HARROW COUNCIL

ADDENDUM

PLANNING COMMITTEE

DATE: 19th January 2022

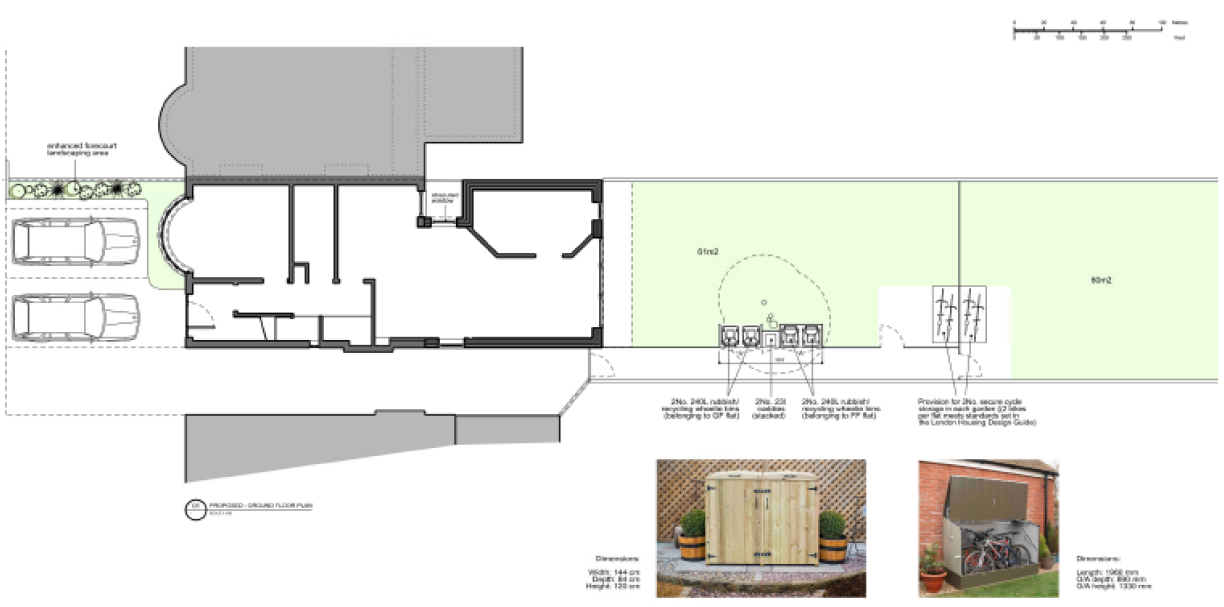
<p>2/03</p>	<p>15 Formby Avenue – P/4077/21</p> <p>Appendix 4, Figure 15 is amended as follows to reflect the proposed site layout.</p>  <p>enhanced forecourt landscaping area</p> <p>PROPOSED GROUND FLOOR PLAN</p> <p>Dimensions: Width: 144 cm Depth: 88 cm Height: 120 cm</p> <p>Dimensions: Length: 1066 mm D/W: 880 mm D/A: height: 120 mm</p> <p>2No. 240L rubbish/recycling wheelie bins (belonging to GP flat)</p> <p>2No. 22L wheelie bins (belonging to PP flat)</p> <p>2No. 240L rubbish/recycling wheelie bins (belonging to PP flat)</p> <p>Provision for 2No. secure cycle storage in each garden (2 bikes per flat made available per the London Housing Design Guide)</p>
<p>2/05</p>	<p>87 Lankers Drive – P/4226/21</p> <p>Add additional text to very end of paragraph 6.2.3 stating the following:</p> <p>Whilst officers do not raise an in-principle objection to its incorporation, limited information has been provided on the external appearance and colouring of the proposed 'aluminium standing seam metal roof'. To ensure that its detailed appearance is satisfactory, a condition has been imposed requiring the applicant to submit material samples for the proposed roof.</p> <p>Alter the wording of Condition No. 3 (Materials) within Appendix 1</p> <p>From:</p> <p>The external surfaces of the development hereby approved shall be constructed in accordance with the details provided within PL-A-01 and the submitted Application Form.</p>
